SERVICE BULLETIN

Service Bulletin No.: DA20-79-07 Rev 0

Title: Oil Quantity Placard DA20-A1/DA20-100

Figure 1
Old Placard

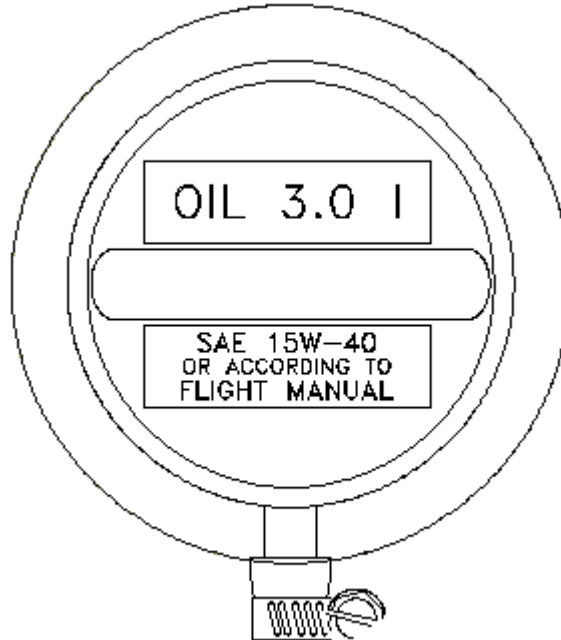
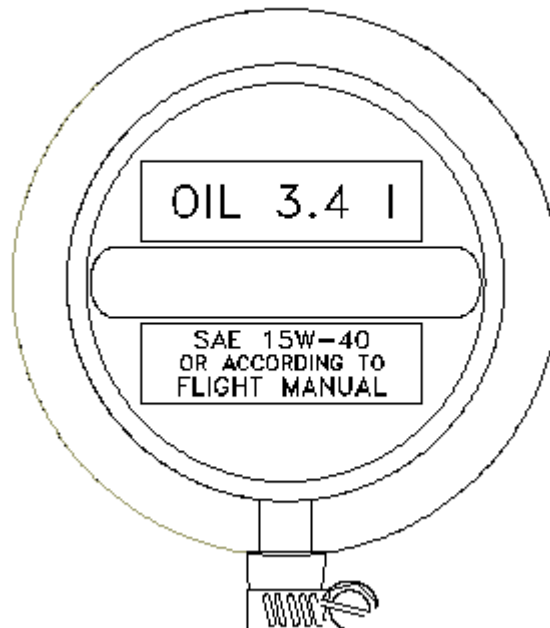
1. **ATA Code:** 7900
2. **Effectivity:** Diamond Aircraft Model DA20 A1 aircraft.
3. **General:** Rotax has specified the use of a new oil dipstick that increases the oil capacity of the 912 A/F/S series engines (SB-912-040 R1). As a result, the oil capacity placard located on the oil reservoir cap must be replaced.
4. **Compliance:** At the next oil change or within the next 100 hours of operation, but at the latest by November 30,2003.
5. **Approval:** The engineering data referenced or contained in this service bulletin is approved as part of the type design.
6. **Labour:** Approximately 5 minutes will be required to accomplish this service bulletin.
This estimate is for direct labor performed by a technician and it does not include setup, planning, familiarization, cure time, part fabrication or tool acquisition.

- 10.1 Remove the existing placard from the oil reservoir cap.
- 10.2 Clean the surface of the oil cap, removing all traces of adhesive, oil or dirt.
- 10.3 Remove the foil backing from the new placard and apply the placard to the oil reservoir cap in the same location and orientation as the existing one.
